Key Words: Standard Hydrogen Monitoring, SHMS, W-369

Abstract: Engineering Report to document moisture problems found during the sampling of the vapors in the dome space for hydrogen in the storage tanks and a recommended solution

**ENGINEERING REPORT
STANDARD HYDROGEN MONITORING
SYSTEM PROBLEMS**

WESTINGHOUSE HANFORD COMPANY
Purchase Order MSJ-SBW-336070
Report No. 961140-002
Revision 0

REFERENCE DRAWING H-2-817852	SH. 1	REV. 1	PREPARED BY: B.GROTH	PAGE 6 OF 14
			ECN No. 625230

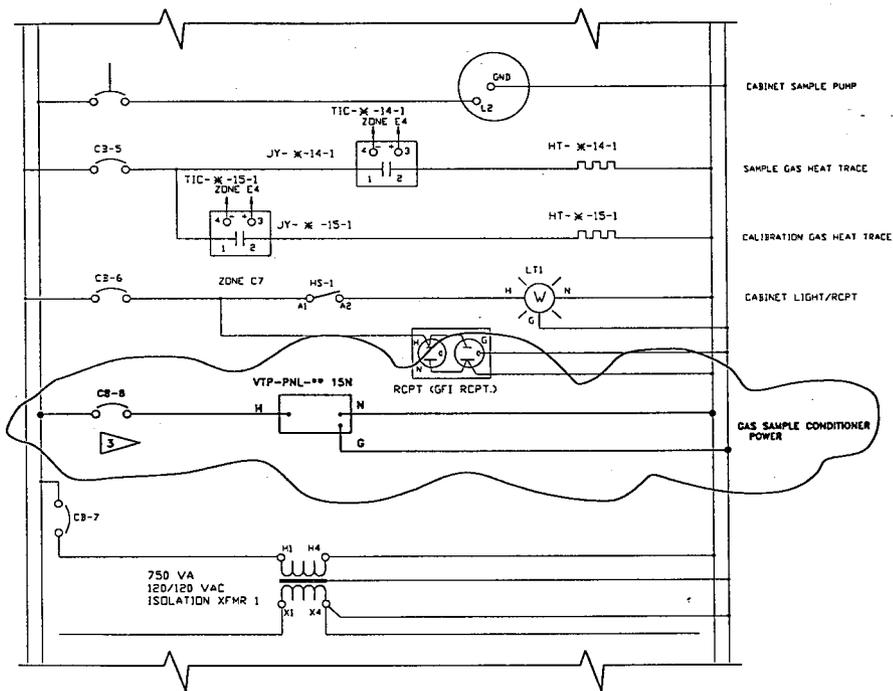
3. CB-B IS ONLY INCLUDED ON SYSTEMS WHERE VTP-PNL-** 15N, SAMPLE GAS CONDITIONER IS INSTALLED SEE H-2-87275 FOR INSTALLED LOCATIONS.

VIEW A-A - SLAB PENETRATION & ANCHOR DETAIL
SCALE: 1/4" = 1"

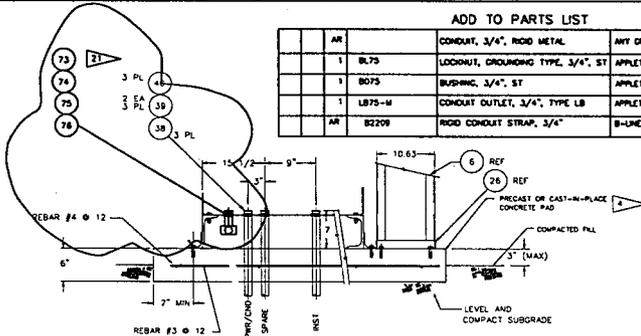
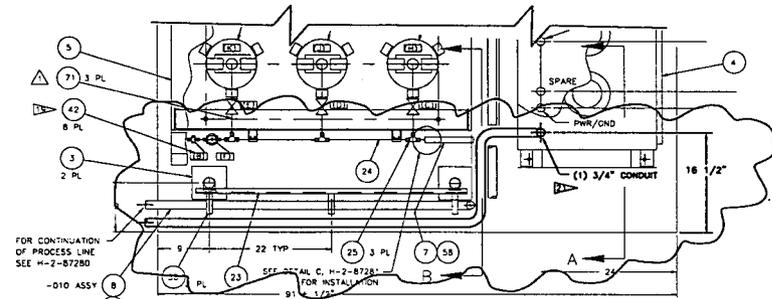
ADD TO PARTS LIST

ADD GENERAL NOTE (21):

Dwg. H-2-73388	Sh. 1	Rev. 4	Prepared by B.Groth	ECN No. 625231	Page 7 of 11
-------------------	----------	-----------	------------------------	-------------------	-----------------

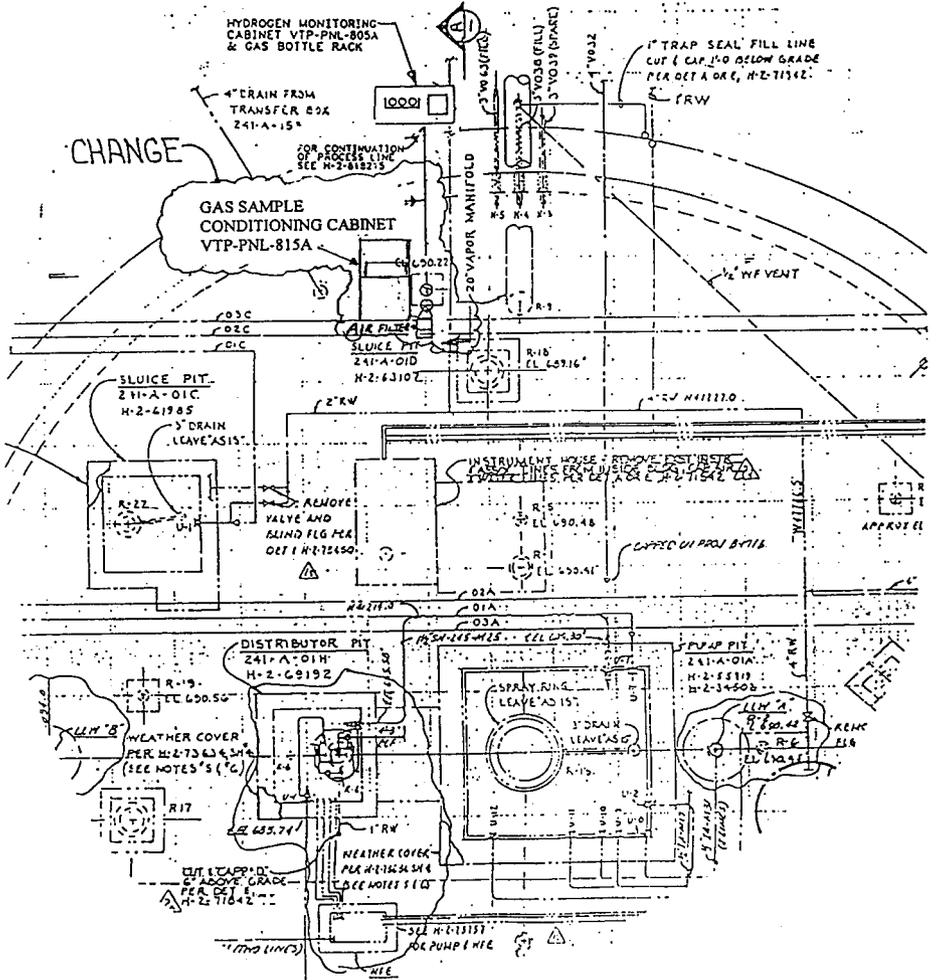
INSTRUMENT HOUSE REMOVE INSTRUMENT HOUSE FLOOR LINE PER DET A OR, H-2-71542

Dwg. H-2-73960	Sh. 1,2	Rev. 1	Prepared by BD Groth	ECN No. 625237	Page 5 of 10
-------------------	------------	-----------	-------------------------	-------------------	-----------------

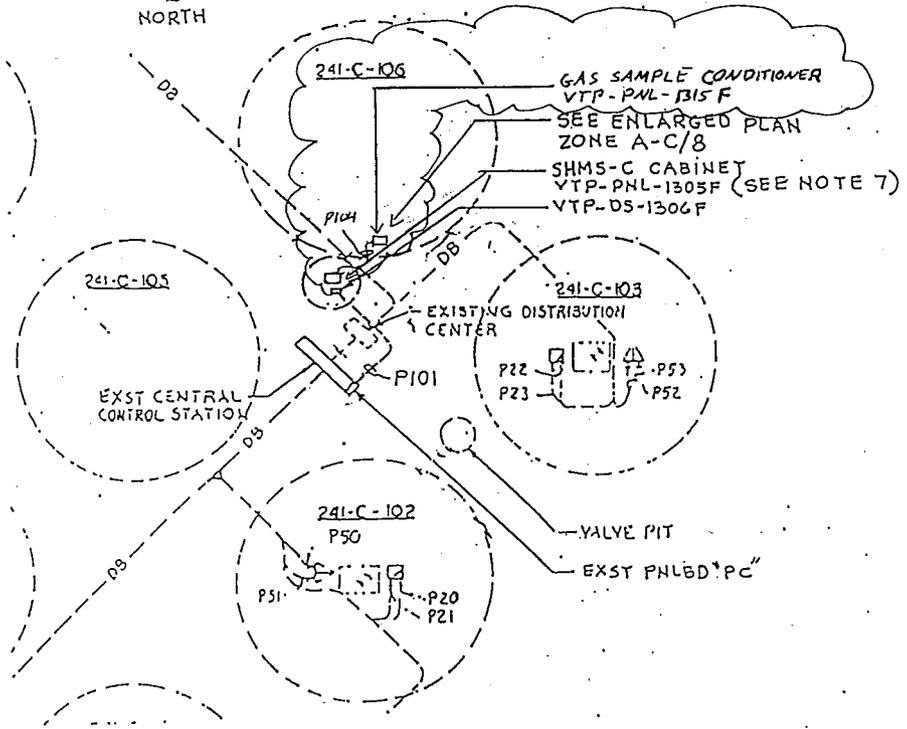
NOTE 7. SEE DWG. H-2-822775 FOR HYDROGEN MONITORING CABINET AND GAS BOTTLE RACK. AND, DWG. H-2-822776 FOR WIRING DIAGRAMS.

CHANGES ECN W-369-55, PAGE 13 OF 15
AS FOLLOWS:

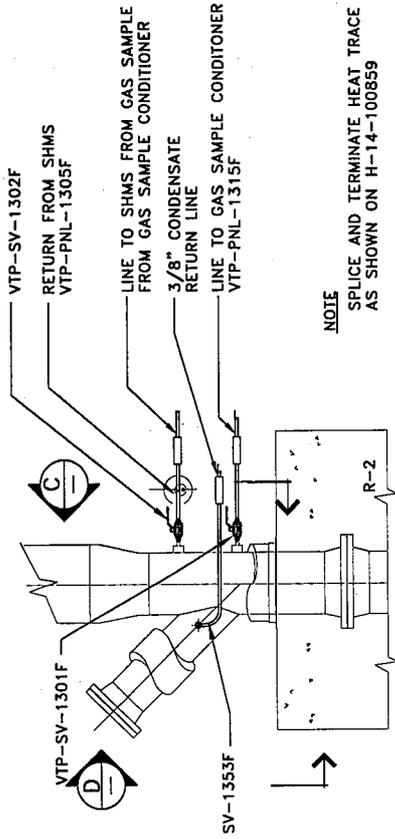
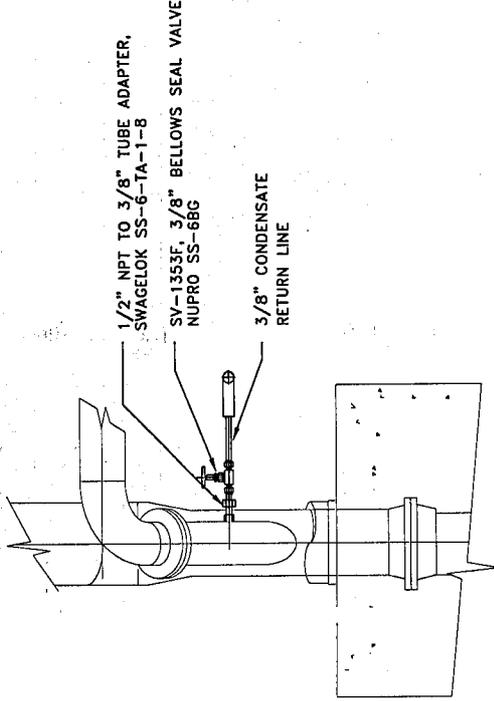
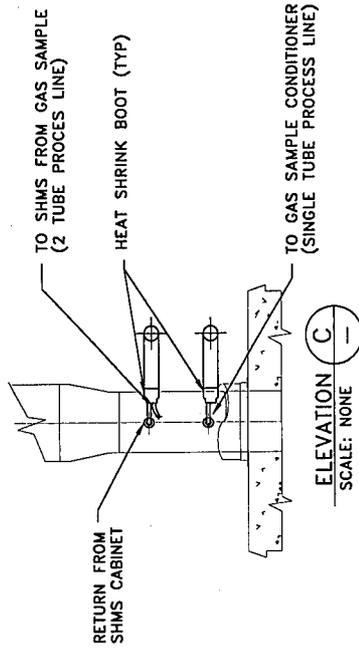
NOTE: EXISTING DETAILS REMOVED FOR CLARITY

NOTE
SPLICE AND TERMINATE HEAT TRACE AS SHOWN ON H-14-100859

Dwg. H-2-818470	Sh. 3	Rev. 0	Prepared by BD Groth	ECN No. 625237	Page 10 of 10
--------------------	----------	-----------	-------------------------	-------------------	------------------

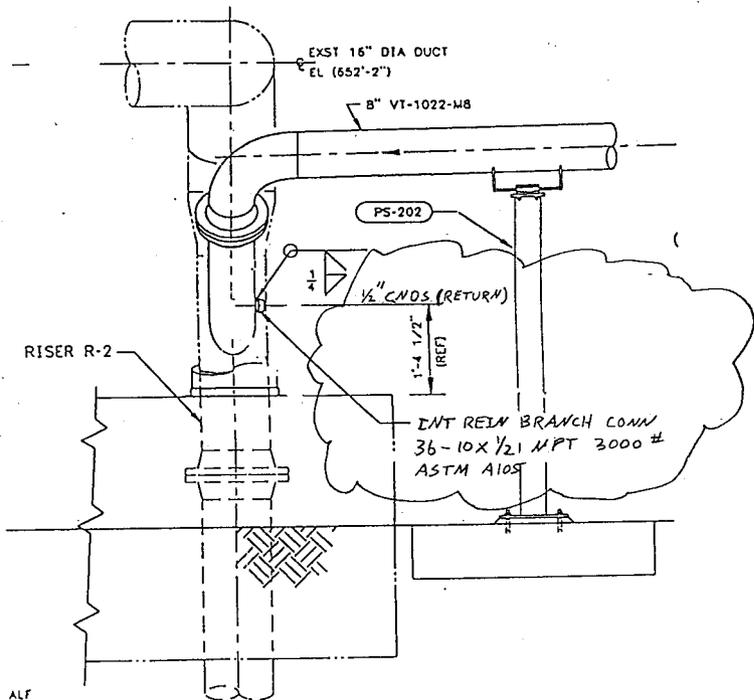
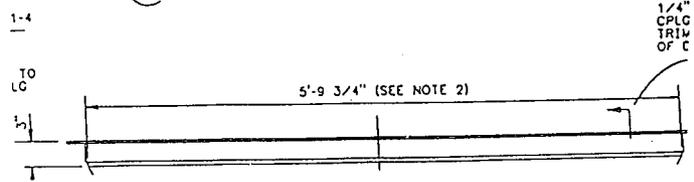
Change page 15 of ECN W-369-55 as shown in clouded area to change condensate return port from 1" to 1/2"

CHANGE ECN W369-56, PAGE 18 AS FOLLOWS

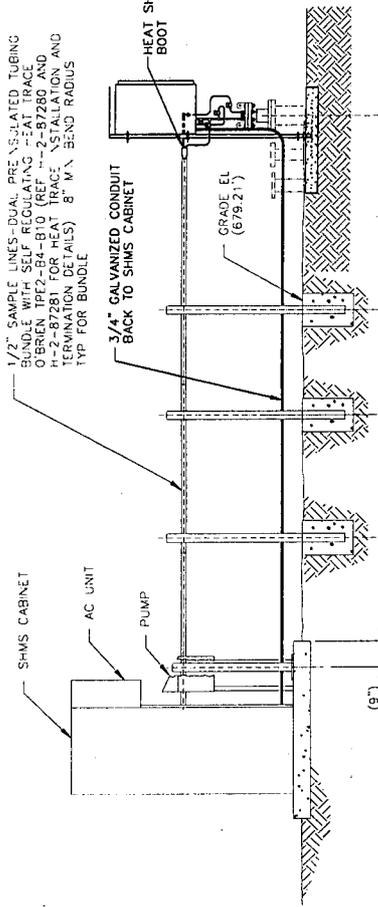
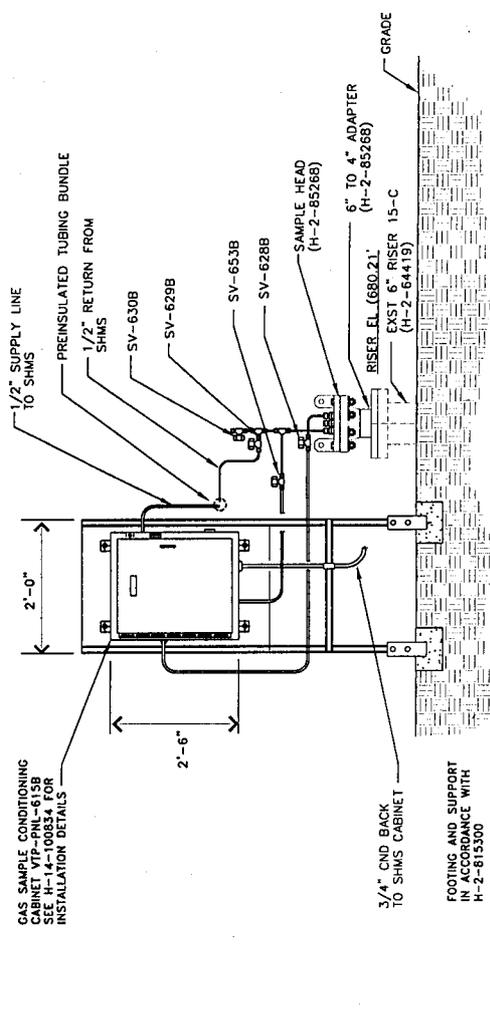
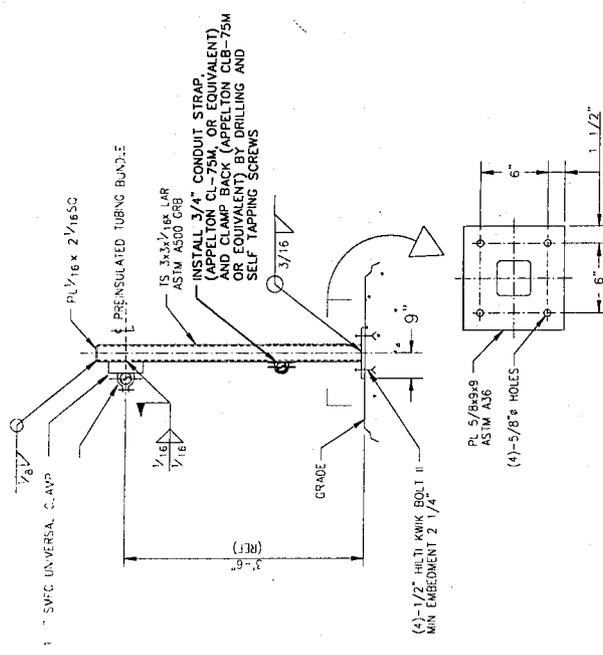
1. SWFC UNIVERSAL C.A.P.
 PL 1/16 x 2 1/16 SQ
 PREINSULATED TUBING BUNDLE
 IS 3/32 x 1/16 IAR
 ASTM A300 GRB
 INSTALL 3/4\"/>

CHANGE ECN W369-56, PAGE 17 AS FOLLOWS

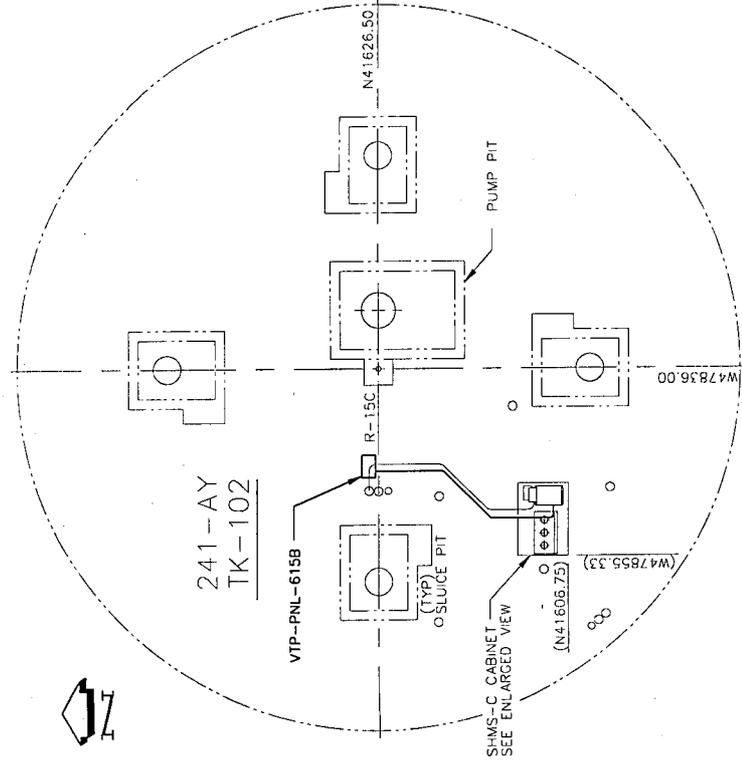
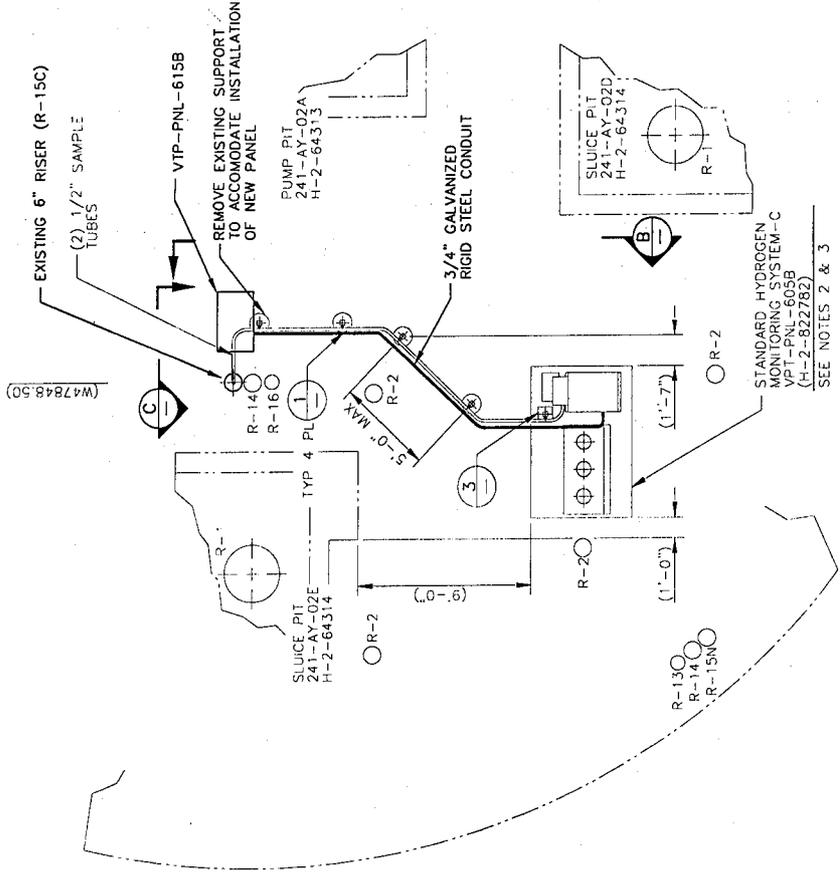
SEE NOTES 2 & 3
